## Author's Response to Short Comment by M. Gebremicheal

We thank Dr. M. Gebremichael for his interest in our paper and for providing very useful and insightful comments. Our responses to his comments are listed below:

Figure 2. Revised manuscript will be updated with Figure 2 on the left. Right: Existing figure 2 in manuscript.

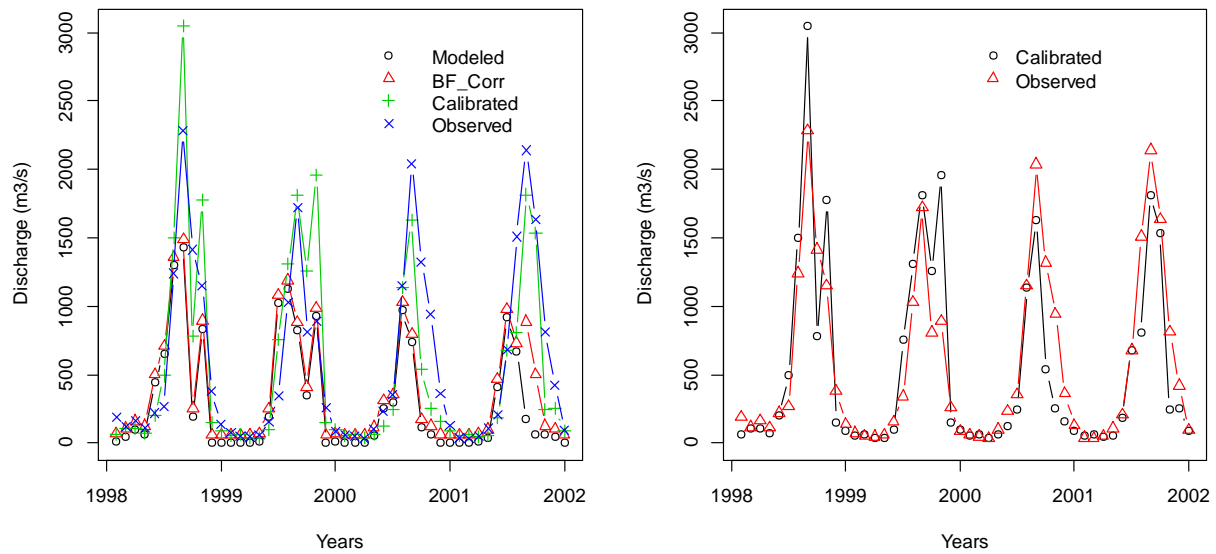
**Comment #8:** On Section 4.1: L 4 what do you mean by “initial comparison”? The whole paragraph is not clear. Which statements do refer to Fig 2 and which statements refer to elsewhere?

**Author’s response:** We agree with the comment that section 4.1 is not clear. Actually, in published Figure 2, we showed only model calibrated vs. observed runoff data and removed un-calibrated runoff data to avoid the clutter. We would add un-calibrated and base flow corrected data to Figure 2 that would demonstrate the underestimation in the modeled runoff data and would also improve the explanation of figure 2 in Section 4.1. Further, we will re-phrase the text in section 4.1 to convey the message clearly. See below for a comparison of new figure and existing Figure 2 in the HESSD manuscript. The new figure shows model un-calibrated (black circles), base flow corrected (red triangles), model calibrated (green plus) and observed runoff data (blue cross).
